Re: 709 Central NW Grading and Drainage Plan
Engineer's Stamp dated 4-30-01 (K14/D80)

RE: 709 CENTRAL AVE NW (K-14/D80)
ENGINEERS CERTIFICATION FOR CERTIFICATE OF OCCUPANCY
ENGINEERS STAMP DATED 4/6/2001
ENGINEERS CERTIFICATION DATED 4/23/2001

A PROPOSED PAVING PLAN
FOR
709 CENTRAL AVE. N.W.
ALBUQUERQUE, NEW MEXICO
APRIL, 2001
(ENGINEER'S CERTIFICATION)
04-23-01

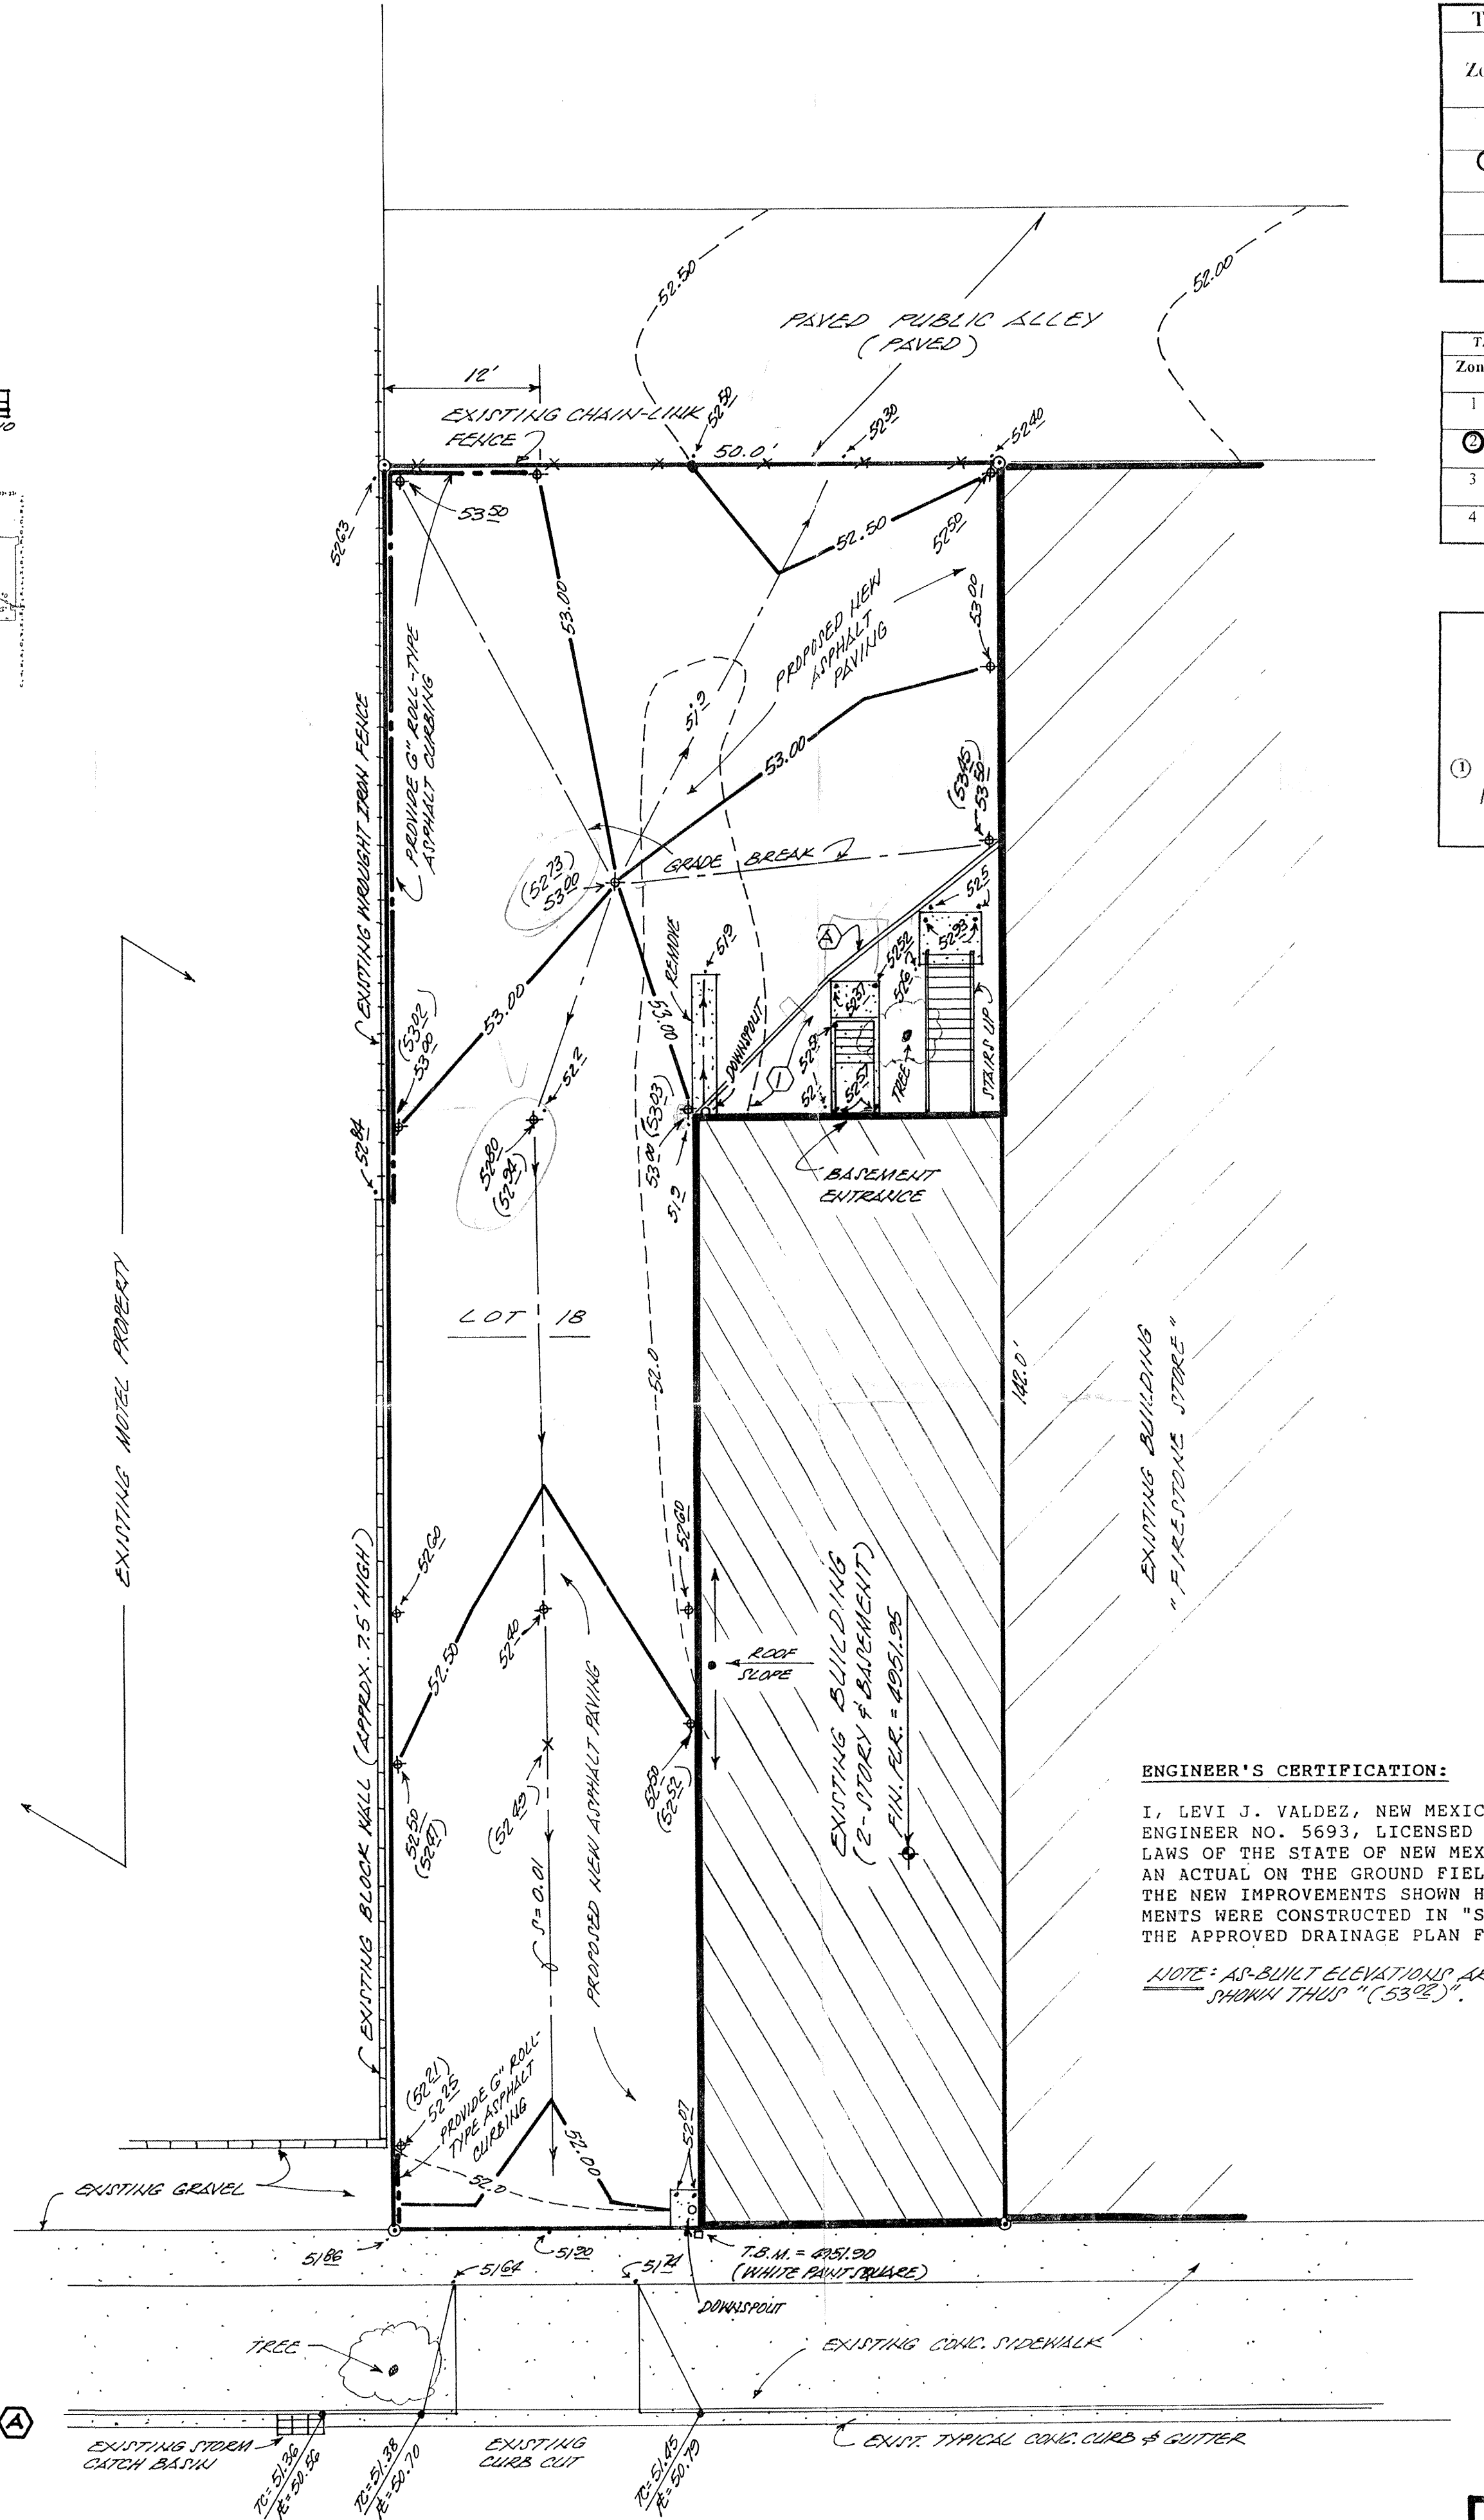
Your Engineers Certification shows a low spot "bird-bath" midway near the rear center of the newly paved portion. This low spot will cause ponding to occur and change the original intent of the approved plans to have the runoff of the rear of the property drain to the alley.

Also the grading and drainage certification states a header curb is installed in front of the stairways from the east property line of the adjacent building to the northwest corner of the building (at the drain spout); However, an on-site inspection revealed that two bumper curbs have been installed instead of the required header curb. This deviation from the approved grading and drainage plan needs to be corrected.

When the corrections have been made as per the approved grading and drainage plans eliminating the low spot with placement of the header curb, and the as-builts resubmitted to the City's Hydrology Division for approval with the correct recertification and new spot elevations, we will take every measure to expedite this submittal, so a Permanent Certificate of Occupancy can be issued.
